Addendum
Remedial Investigation Report
Soil Investigations Adjacent to
Outfall 003

Farrell Road Plant
Geddes, New York
NYSDEC Site No. 734055

Lockheed Martin Corporation
Syracuse, New York

August 1996

PROPOSED SOIL SAMPLE LOCATIONS		
PREPARED FOR LOCKHEED MARTIN CORPORATION		
 ERM	SCALE 1" = 20'	2
	DATE JUNE 1985

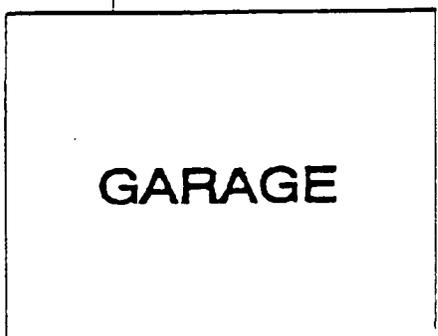
- * The sample grid proposed does not include any samples located within the drainage swale: either some of the sampling points should be moved to within the swale, or additional sampling points should be added. One of the samples sent for lab analysis via Method 8080 should be the farthest sample collected from the swale.

NYSDEC Comment 1 The sample grid proposed does not include any samples located within the drainage swale: either some of the sampling points should be moved to within the swale, or additional sampling points should be added. One of the samples sent for lab analysis via Method 8080 should be the farthest sample collected from the swale.

MMC Response Figure 2 from the 28 June 1995 ERM-Northeast, Inc. (ERM) letter report has been modified to relocate two samples to within the swale (see revised Figure 2 attached to this letter). Additionally, the farthest sample collected from the swale will be sent to an analytical laboratory for analysis by USEPA Method 8080.

WETLAND SOIL SAMPLE LOCATIONS AREAS WITH PCBs > 1 PPM		
PREPARED FOR MARTIN MARIETTA CORPORATION		
 ERM	SCALE 1" = 20'	FIGURE 2
	DATE OCTOBER 1995

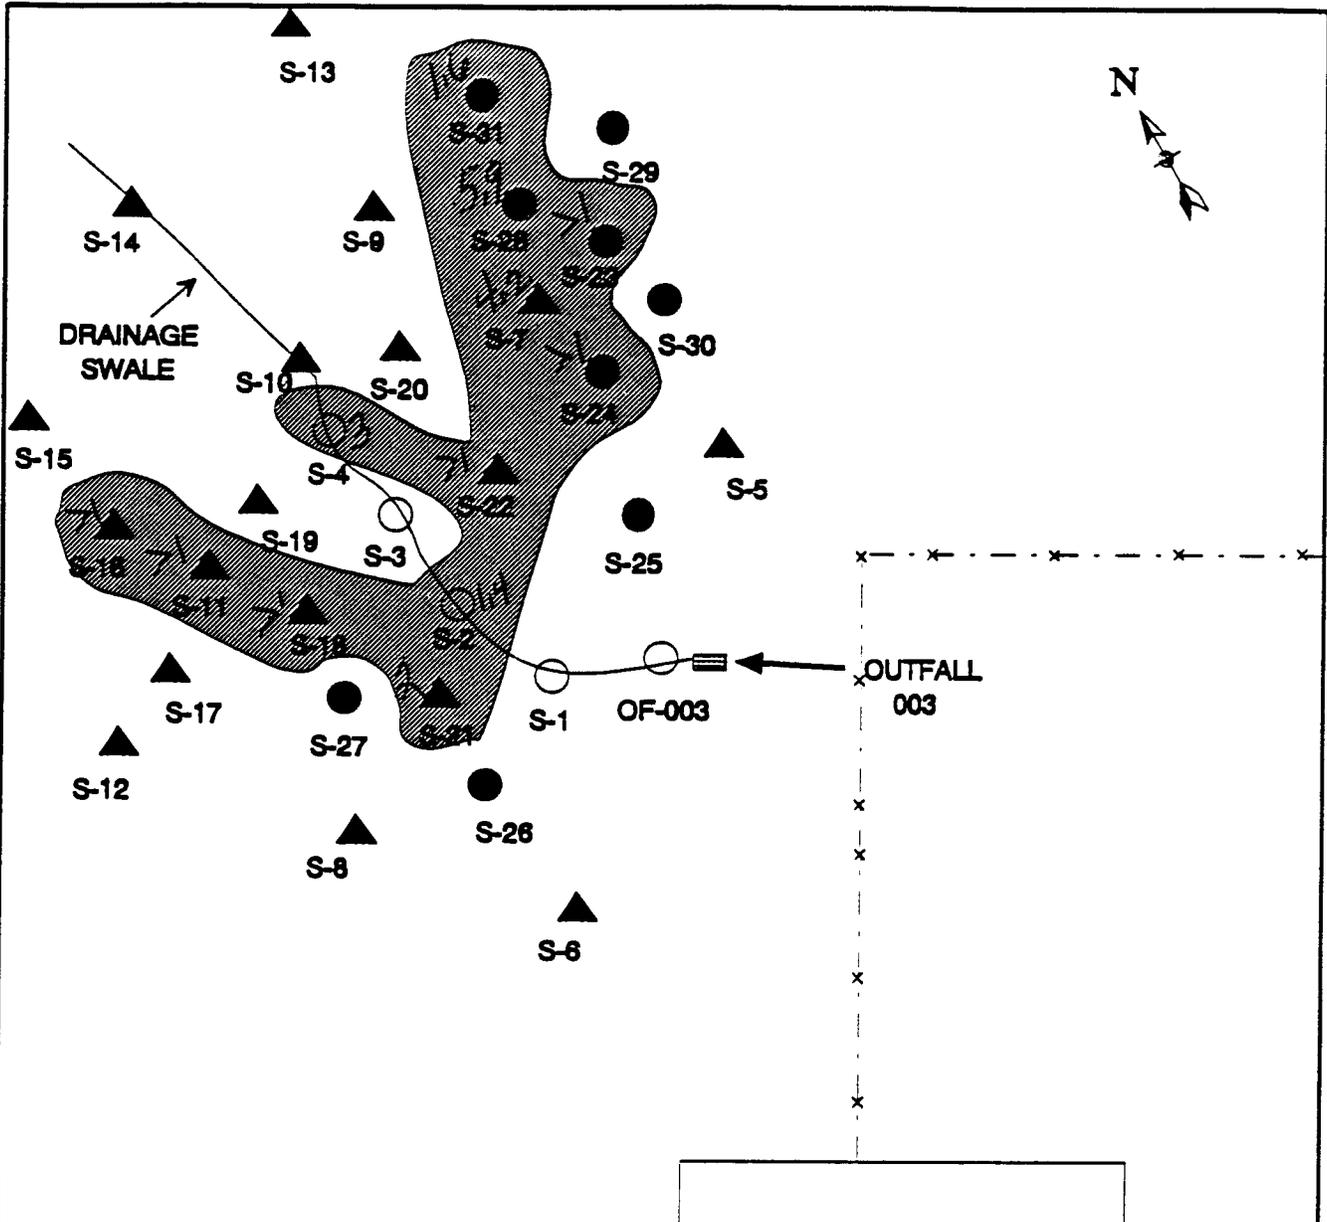
The results of the initial RI samples collected at outfall 003 are needed for accurate interpretation of the analytical data. These results are to be included in Table 1, and the results must be incorporated in Figure 2, showing extent of PCB contamination.

The results of the initial RI samples collected at outfall 003 are needed for accurate interpretation of the analytical data. These results are to be included in Table 1, and the results must be incorporated in Figure 2, showing extent of PCB contamination.

As requested, LMC will include the analytical data from outfall 003 collected during the Remedial Investigation (RI) in Table 1 and Figure 2 of the RI Report Addendum. Three samples collected during the RI were designated FRP-OUT-03A, FRP-OUT-03B, and FRP-OUT-03C. Samples 03A and 03B were collected directly in front of the outfall at the surface and at a depth of one foot below grade respectively. Sample 03C was collected from the surface soil approximately 12 feet downgradient of the outfall.

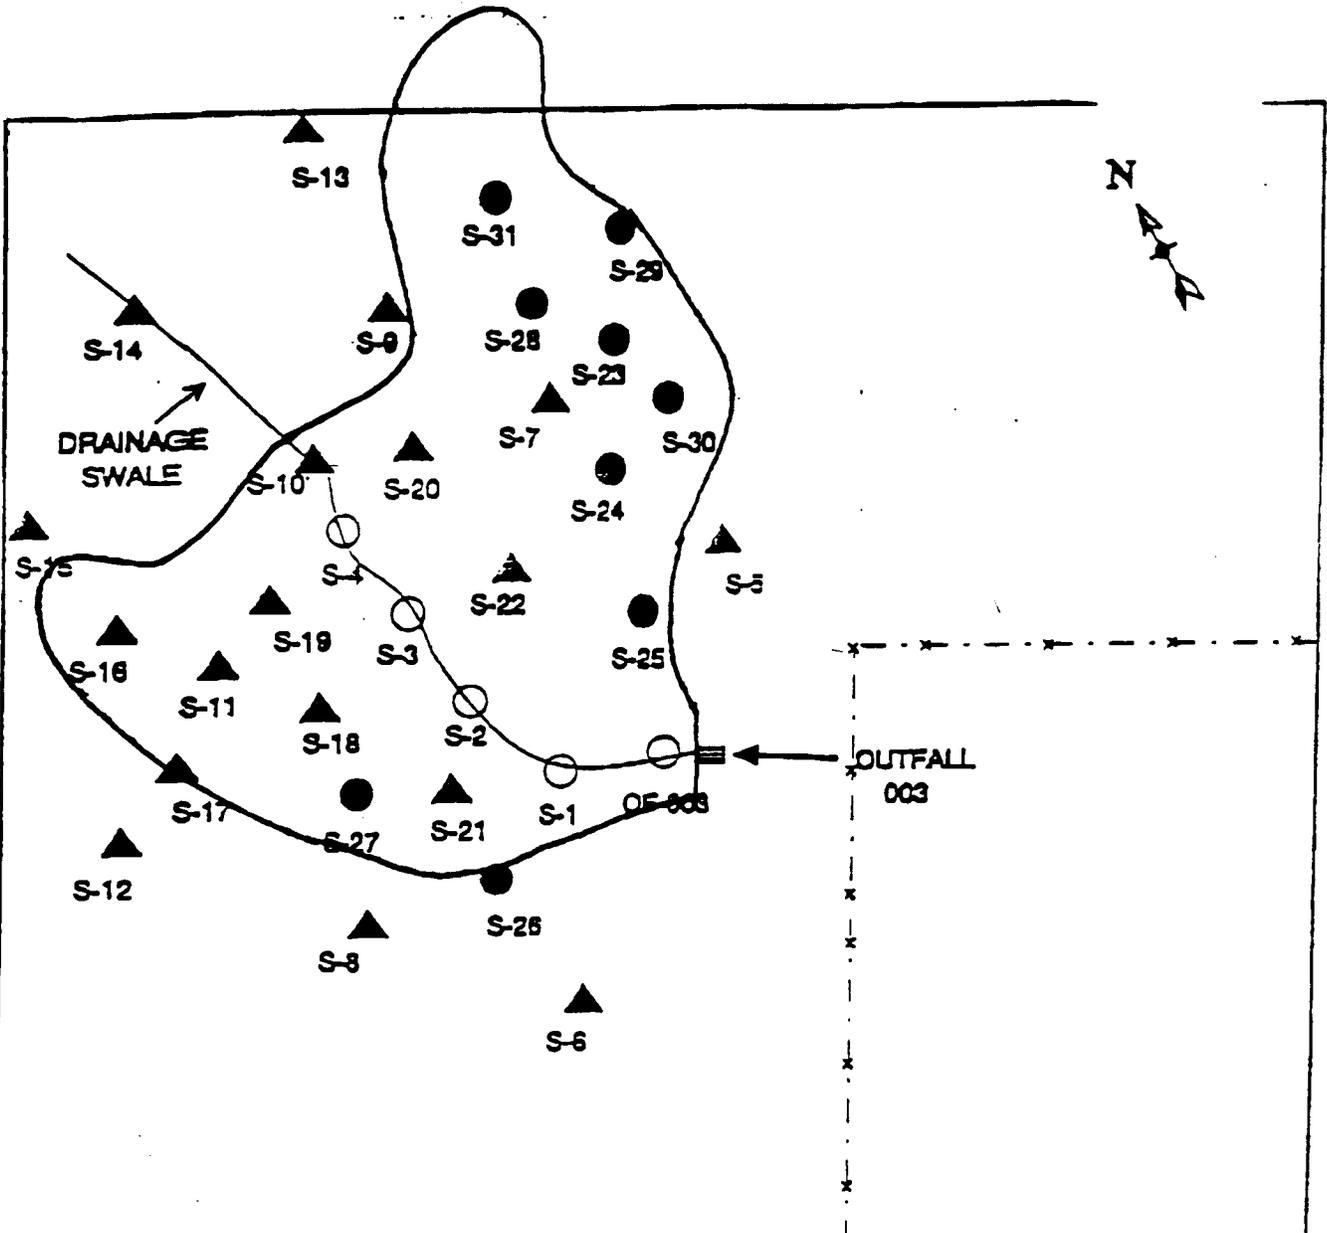
As discussed at the meeting on March 12, 1996, we propose that the extent of remediation be determined by area, rather than by cleanup objectives. On the attached figure are shown proposed boundaries for the remediation, for consideration in the Feasibility Study.

As discussed at the meeting on March 12, 1996, we propose that the extent of remediation be determined by area, rather than by cleanup objectives. On the attached figure are shown proposed boundaries for the remediation, for consideration in the Feasibility Study.

LMC concurs with the NYSDEC that defining the extent of remediation for the soils adjacent to Outfall 003 by area rather than by cleanup objectives is an effective remedial approach. Although the horizontal area delineated by NYSDEC for remediation is significantly larger than the area presented in Figure 2 of LMC's November 29, 1995 report, LMC agrees to remediate the area proposed in the NYSDECs March 29, 1996 letter. Remediation will be completed by removing the top foot of soil from within the defined area. To more easily define the area to be remediated and complete the remediation, LMC may elect to remove soil from beyond the area proposed by the NYSDEC; the remediation area will include, at a minimum, the entire area proposed by the NYSDEC. The removed soil will be transported off-site for disposal.

BBL BLASLAND, BOUCK & LEE, INC.
engineers & scientists **FIGURE 3**

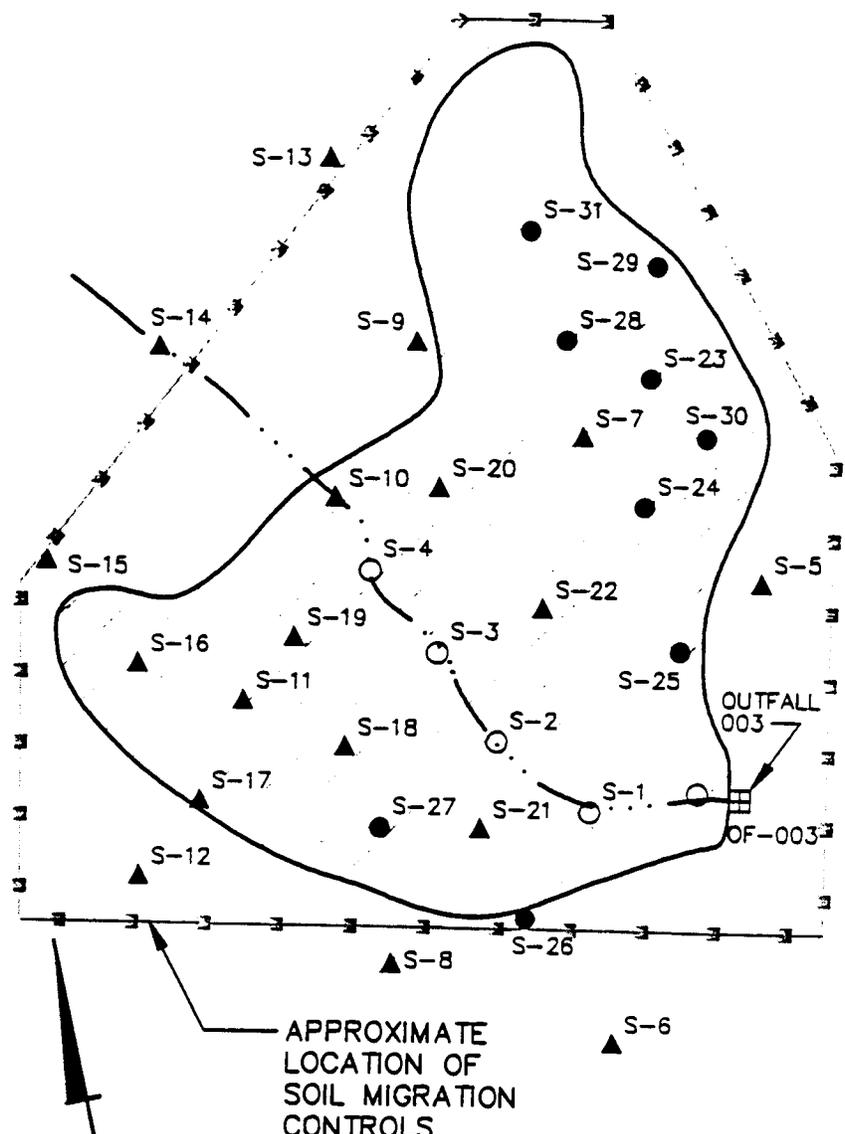
- 2- Section 2.4: The sediment control should be a silt fence and hay bales. The approximate limits of the silt fence should be shown on Figure 3 and the figure referenced in this section.

NYSDEC Comment 2 Section 2.4: **The sediment control should be a silt fence and hay bales. The approximate limits of the silt fence should be shown on Figure 3 and the figure referenced in this section.**

LMC Response Soil migration control will include silt fence and haybales. The approximate location of the soil migration controls is shown on the attached, revised Figure 3. As stated in the IRM Work Plan the soil removal area may be extended during the execution of the IRM to simplify the delineation of the perimeter of the remediation area. If the soil removal area is extended, the location of the soil controls will be adjusted in the field to encompass, at a minimum, the soil removal area.
